## ENGINE DOOR CYLINDER ANCHOR CHECK H SERIES Prevost vehicles

On the vehicles affected by this bulletin, tighten the ball studs on the engine bay door gas springs

Figure 1

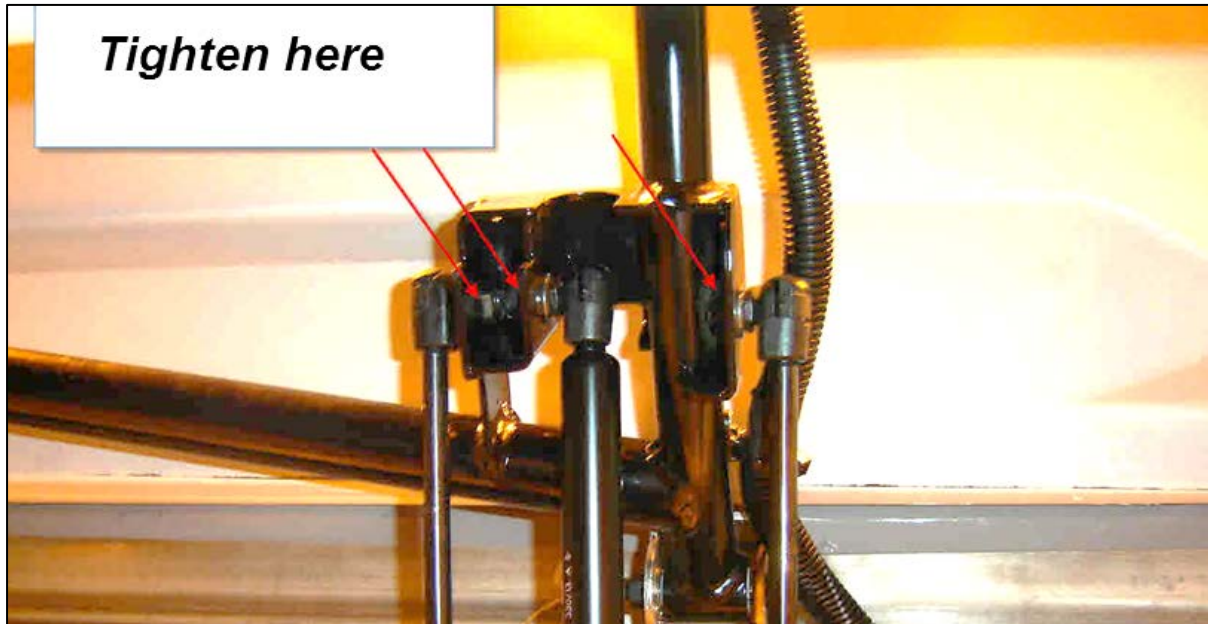
- 1) Tighten the ball studs hand-tight at the indicated locations (3 places) (Fig 1, 2).
- 2) Tighten by the stud hex section. Do not try to tighten the nuts on the bracket as they are welded.
- 3) Test door operation.
